APPEAL SUMMARY

Status: Decision Rendered - Reconsideration of ID 20351

Appeal ID: 20400	Project Address: 450 SW Yamhill St
Hearing Date: 5/15/19	Appellant Name: Tom Jaleski
Case No.: B-010	Appellant Phone: (503) 488-5651
Appeal Type: Building	Plans Examiner/Inspector: Chanel Horn
Project Type: commercial	Stories: 17 Occupancy: B, M, S Construction Type: I-A, II-B
Building/Business Name:	Fire Sprinklers: Yes - Throughout
Appeal Involves: Alteration of an existing structure	LUR or Permit Application No.: 12-117731-EA
Plan Submitted Option: pdf [File 1] [File 2] [File 3] [File 4] [File 5]	Proposed use: Mercantile

Pioneer Place Flagship Upgrade
Portland, OR

PERMIT #12-172313-CO (2012)
LEVEL 2

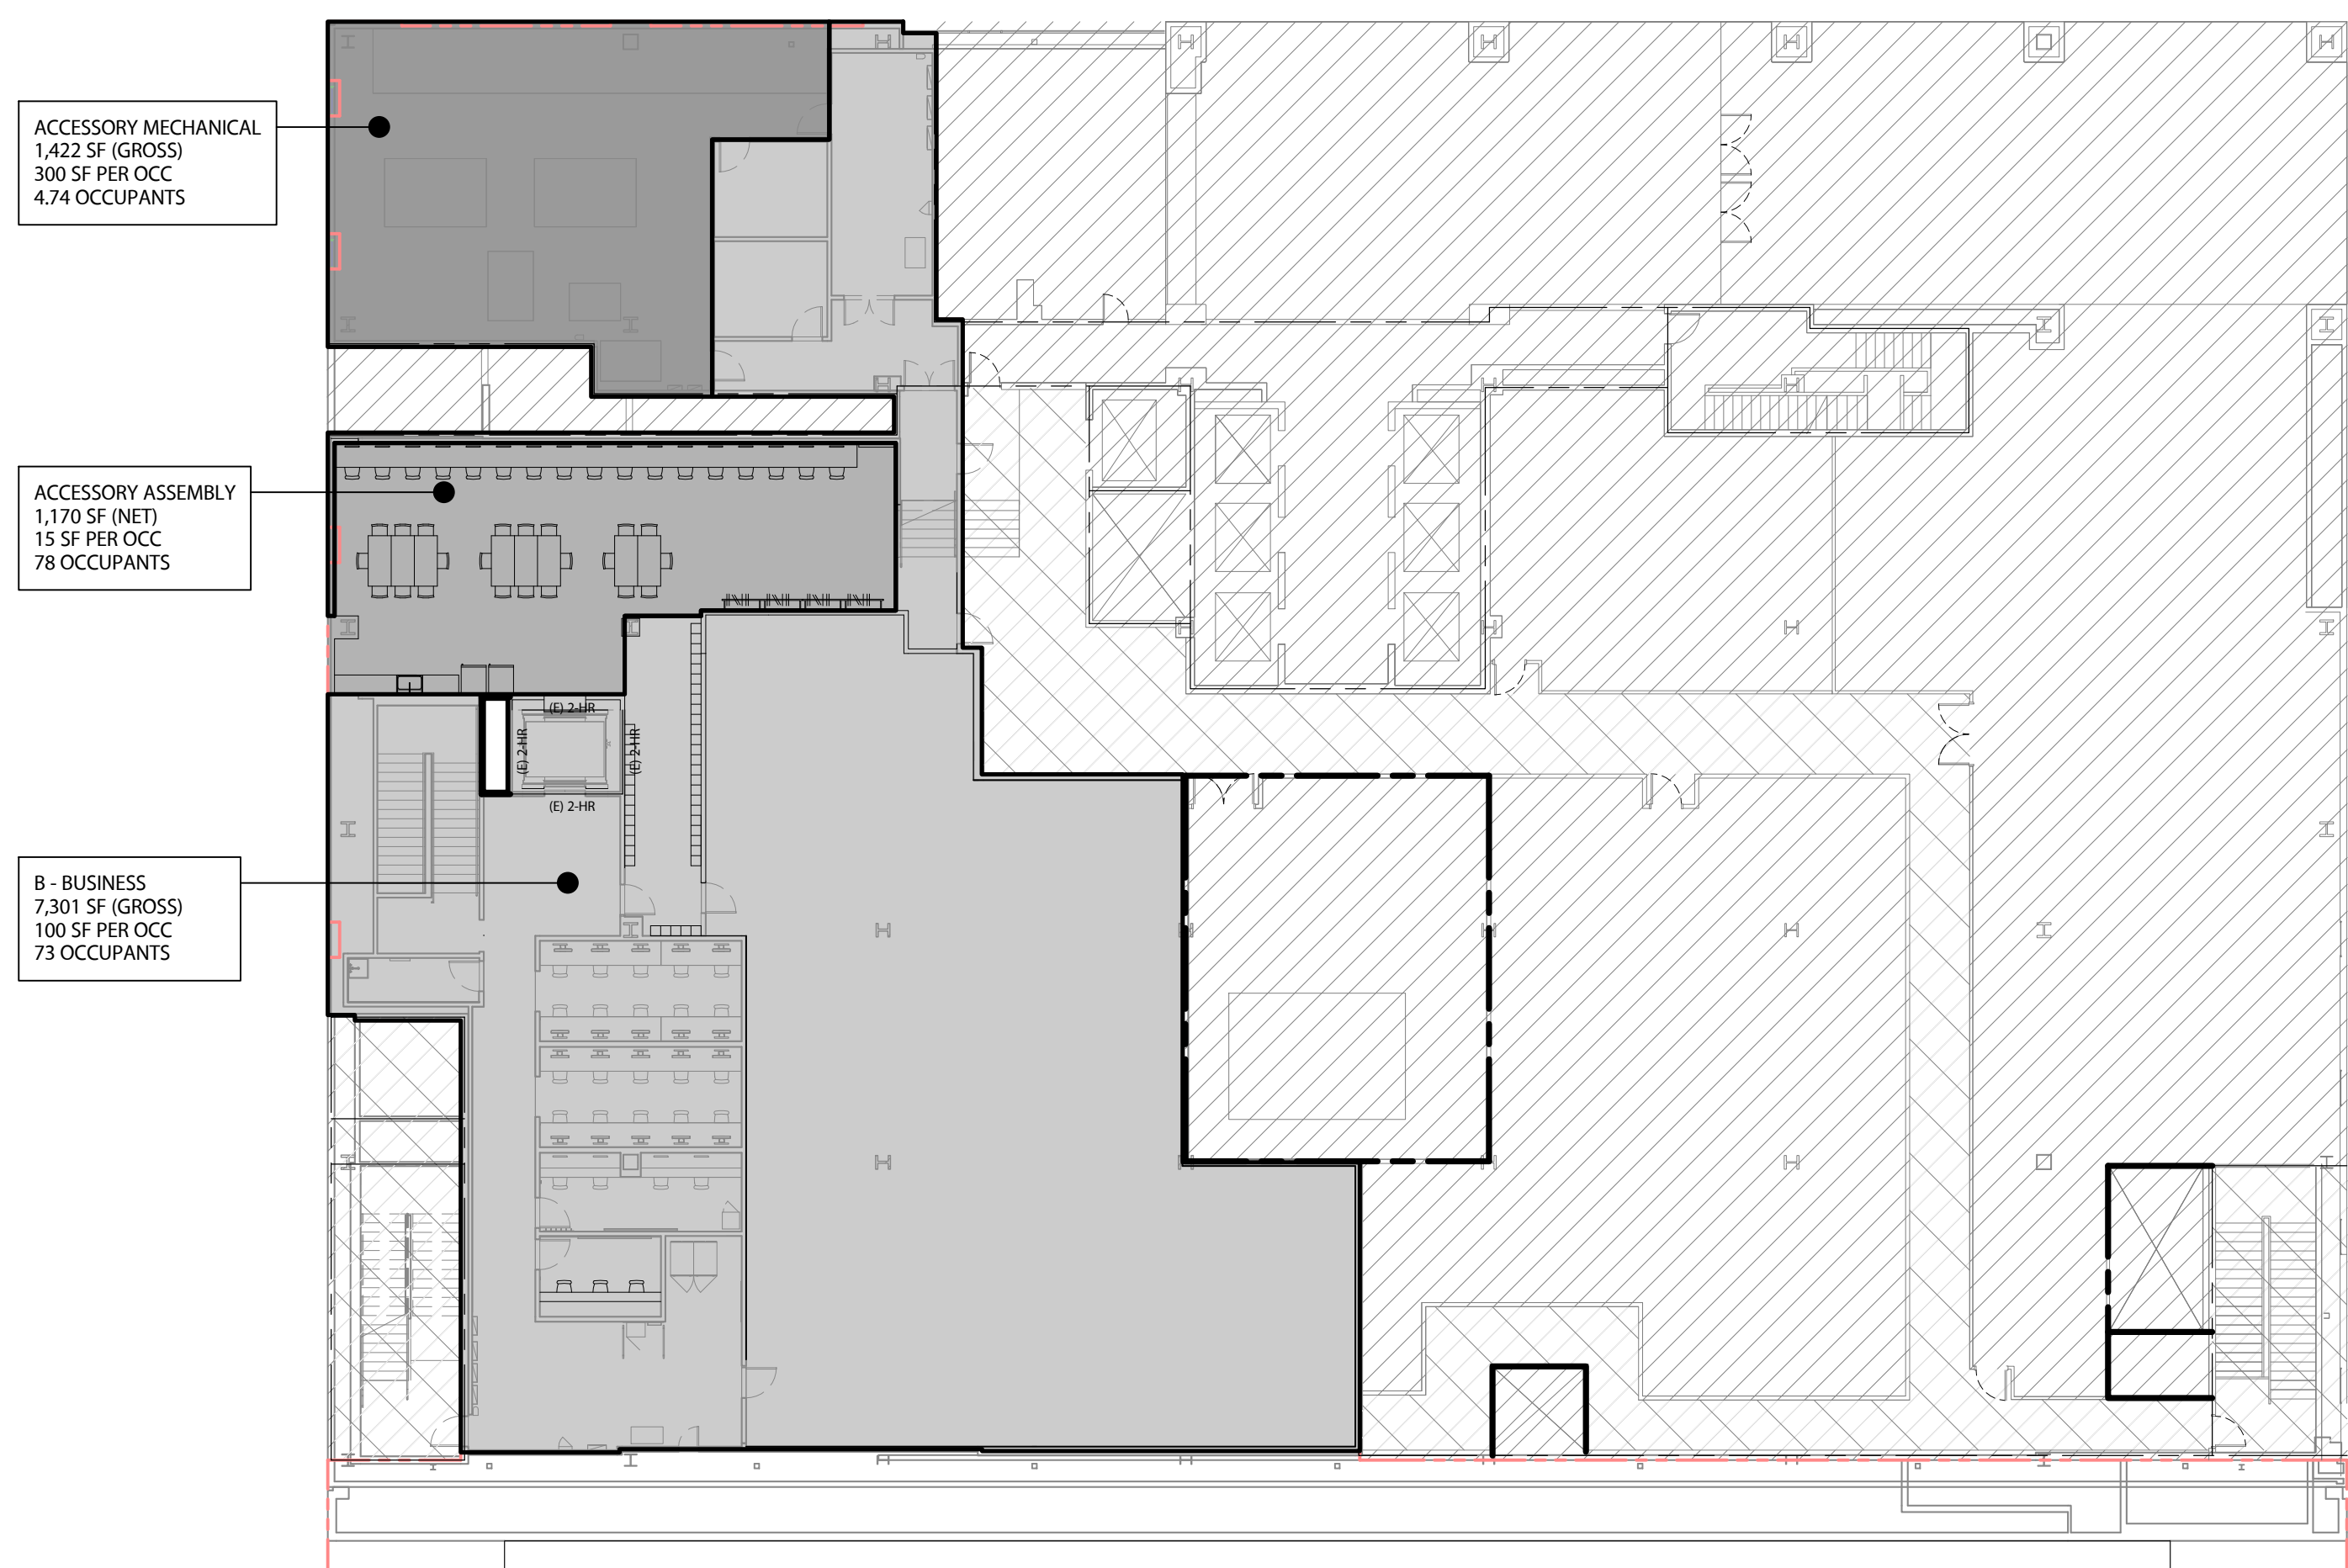
The tenant improvement results in an occupant load decrease of 17 occupants as indicated on the occupant comparison table (attached).

LEVEL 2 PLANS COMPARISON			
SPACE	OCCUPANT LOAD	SQUARE FOOTAGE	OCCUPANTS
ACCESSORY ASSEMBLY	15 NET	1,170 SF	78
B - BUSINESS	100 GROSS	7,301	73
ACCESSORY MECHANICAL	300 GROSS	1,422	4.74
TOTAL OCCUPANT LOAD		9,894	155

2. Omission of full building seismic analysis due to 2nd floor tenant improvement: Denied. Proposal does not provide equivalent Life Safety protection.

OCCUPANCY
COMPARISON - SECOND
LEVEL

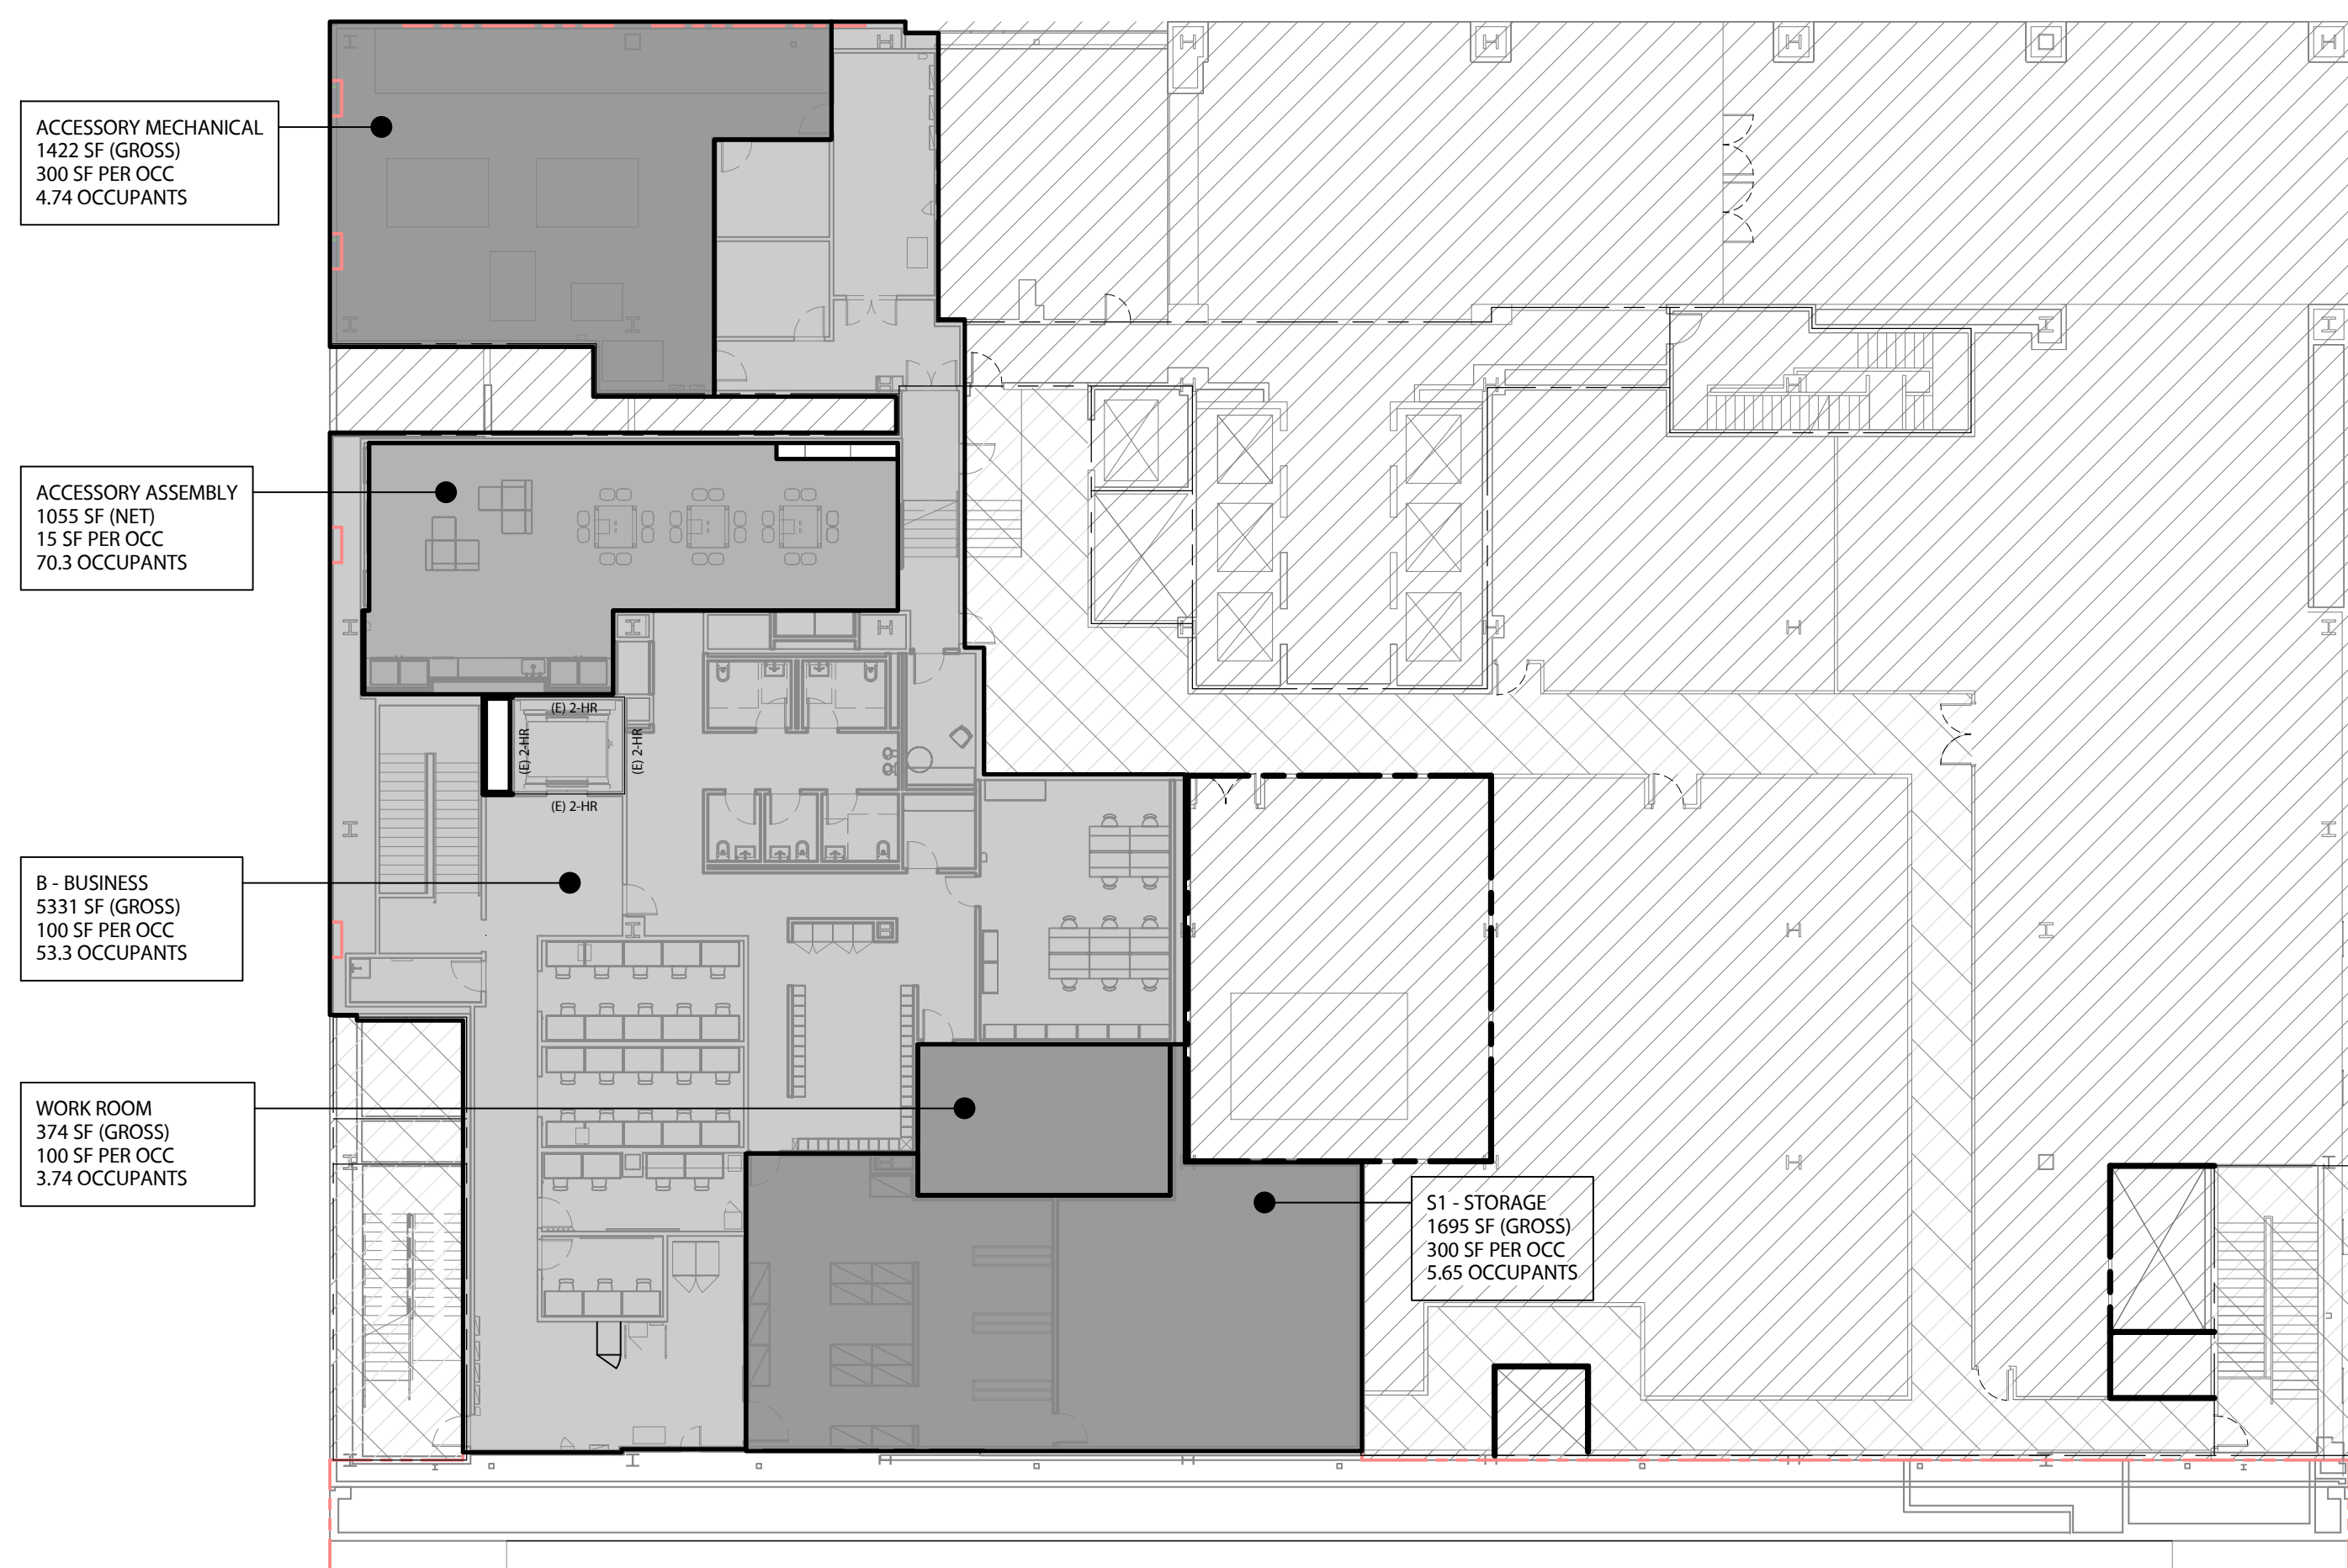
PERMIT #12-172313-CO (2019)
LEVEL 2

LEVEL 2 PLANS COMPARISON			
SPACE	OCCUPANT LOAD	SQUARE FOOTAGE	OCCUPANTS
ACCESSORY ASSEMBLY	15 NET	1,055 SF	70.3
B - BUSINESS	100 GROSS	5,331 SF	53.3
WORK ROOM	100 GROSS	364 SF	3.74
ACCESSORY MECHANICAL	300 GROSS	1,422 SF	4.74
STORAGE	300 GROSS	1,695 SF	5.65
TOTAL OCCUPANT LOAD		9,867 SF	138

NET CHANGE FROM PRIOR PERMIT: -17
